Architectural Review and
Historic Preservation Board
Agenda Report

File: AR 16-08

RE: Architectural Review 16-08 (van Overbeek) – The Arcadian Courtyard Apartments
249 W. 8th Avenue, APN 003-573-001

ARB-4a ELEVATIONS

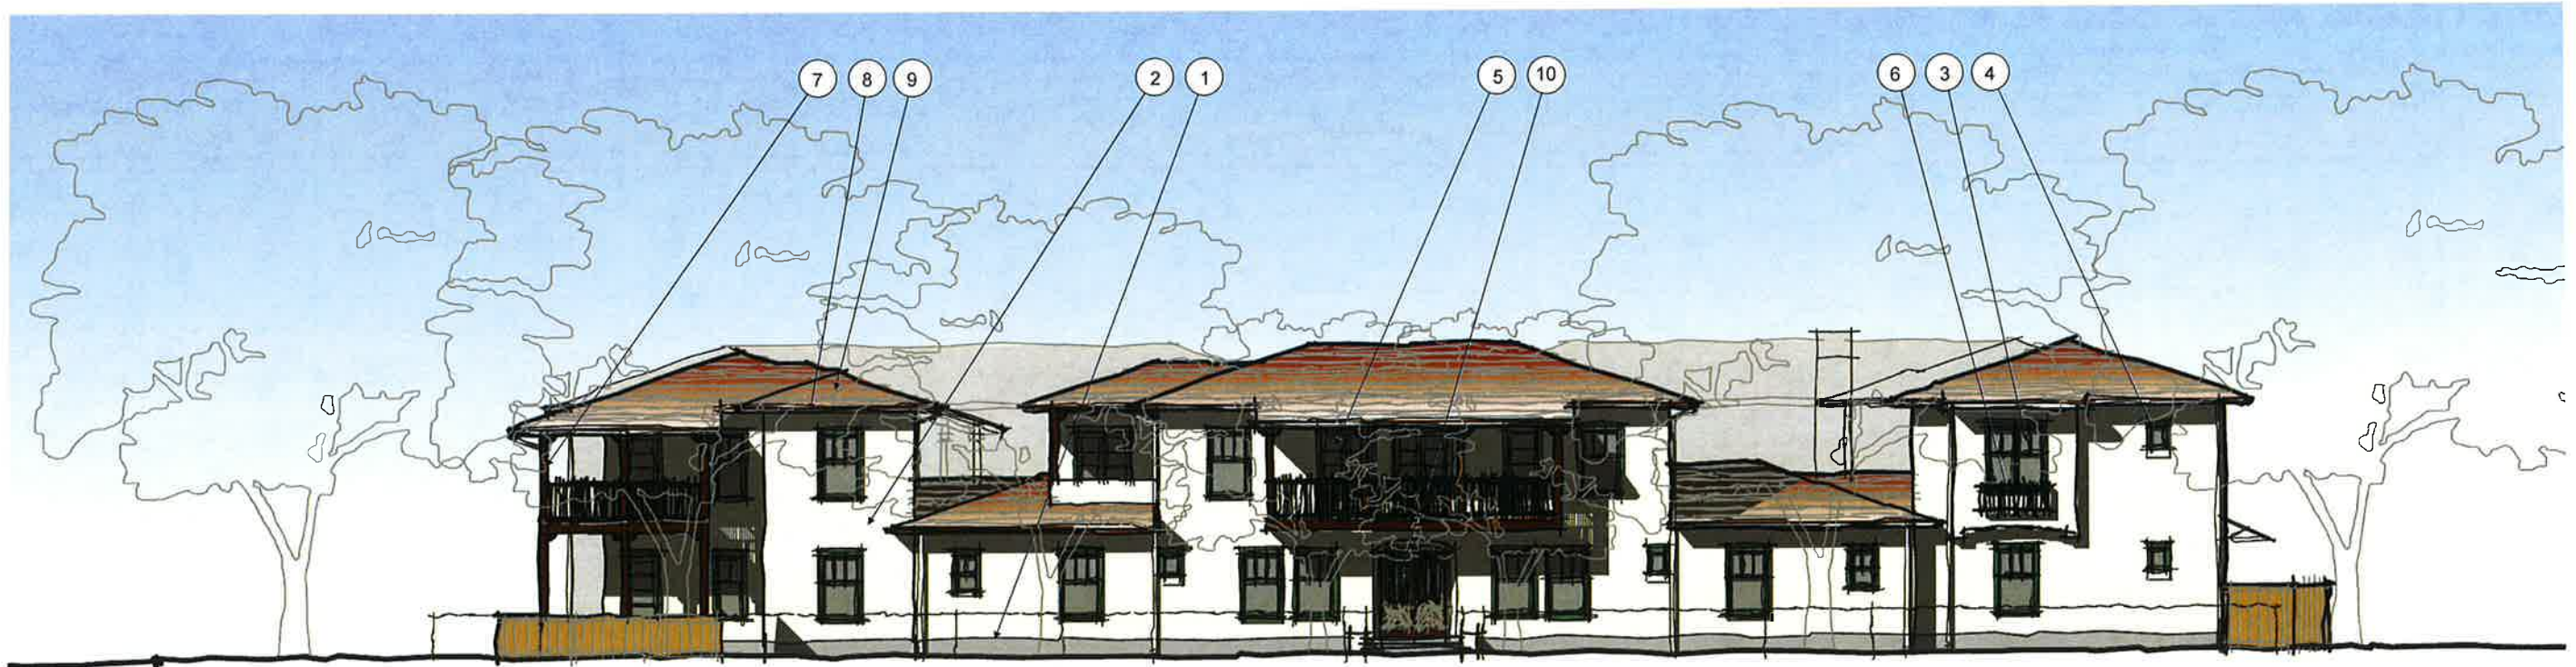
Building architecture provides a clear interpretation of the Monterey Style (or Monterey Revival) which blends old Spanish elements including stucco walls, heavy timber balcony beams, columns, guard rails, window, and door trim (see elevations, **Attachments E1, E2, and E3**). A historic narrative on the Monterey Style is provided in **Attachment F**. Wall surfaces are stucco with integral color of La Habra "Eggshell". Composition roofing color is "Spanish Tile"; gutters and downspouts are Sherwin Williams "Pewter"; door and window frames are "Patina Green"; wrought iron accents are Sherwin Williams "Enduring Bronze"; and wooden balconies are Sherwin Williams "Rockwood Dark Brown" (see material/color details, **Attachment E3**). **Attachment E3** also illustrates details of the trash enclosure (block wall, timber trellis, and lilac vines) and decorative wood privacy fences, 4-feet and six-feet tall.

ARB-3 LANDSCAPE PLAN

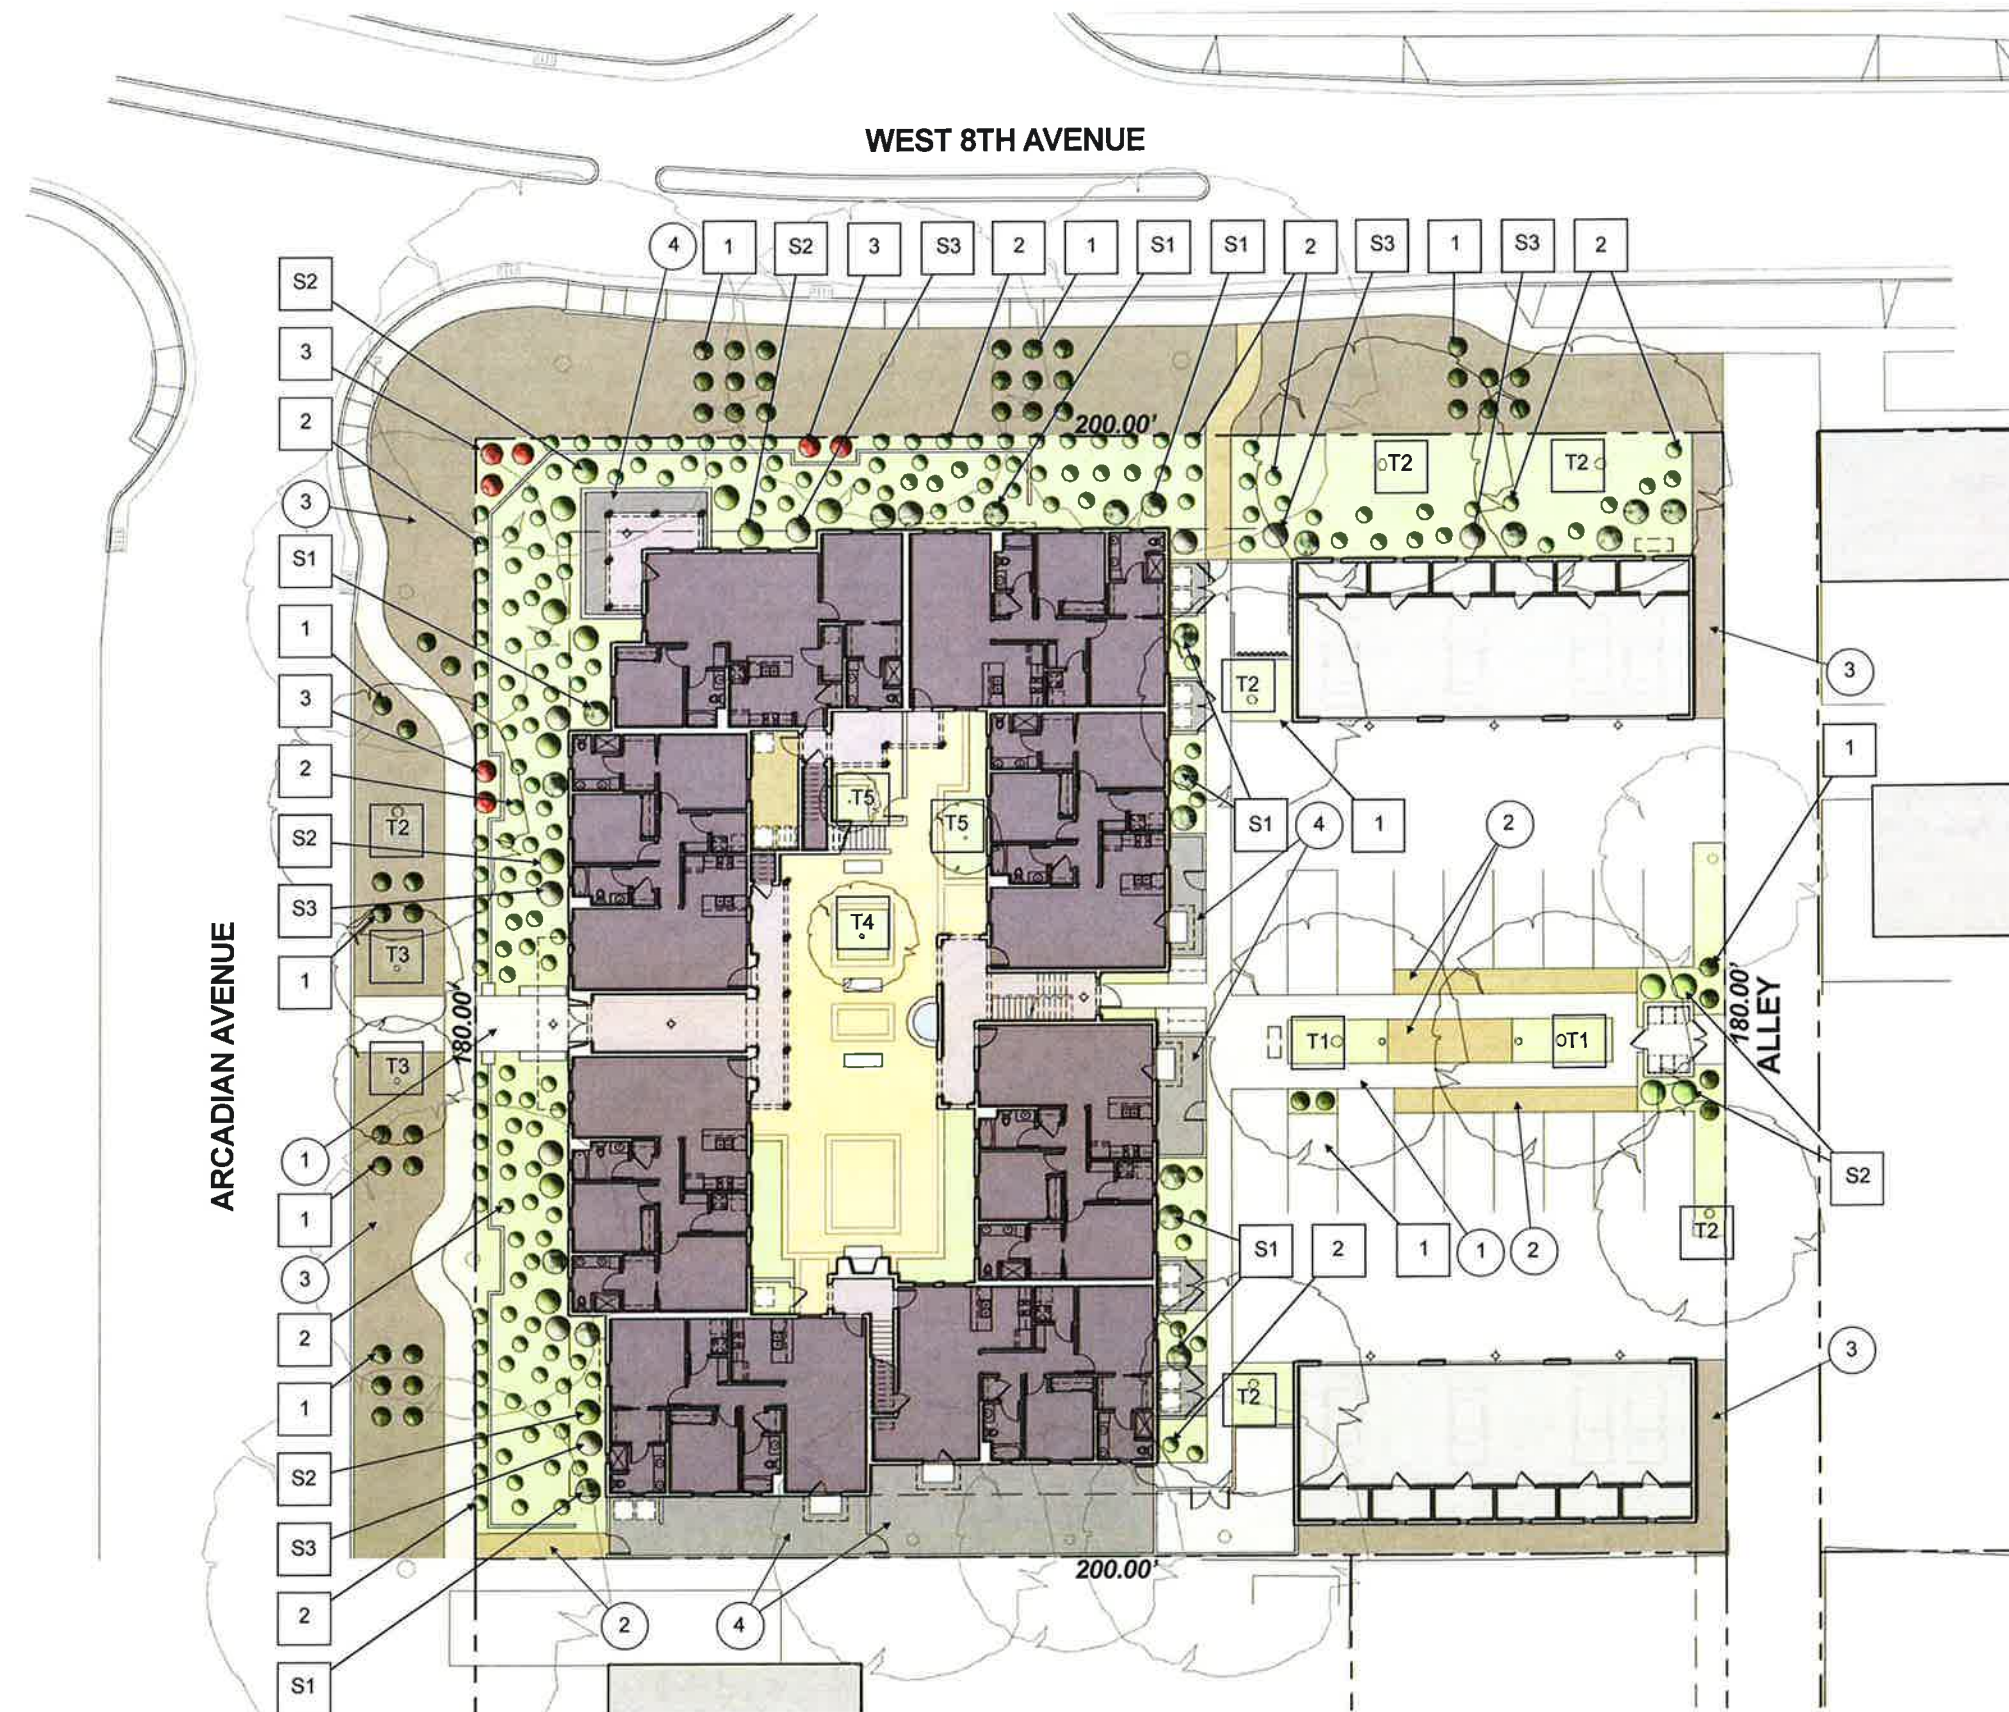
The proposed landscape plan illustrates that 10 mature trees (predominantly large sycamores) will be preserved around the periphery of the site and incorporated with new plantings (see landscape plan, **Attachments G1 and G2**). As illustrated, new plantings include scarlet oak trees providing 62 percent shading of exterior parking areas, October glory maple trees for shade and accent in the parking area, and crape myrtle and dogwood trees for accents at the front entry and courtyard. The preserved trees lend immediate compatibility with the established character of the neighborhood and maintain the shaded atmosphere of the tree lined streets. Although not visible from the exterior of the project, gravel ground cover is proposed for internal courtyards at various units, without a specific type of gravel noted. Staff recommends the Board discuss the purpose of this feature (likely for easier maintenance) and whether it should be enhanced for consistency with otherwise higher quality features.
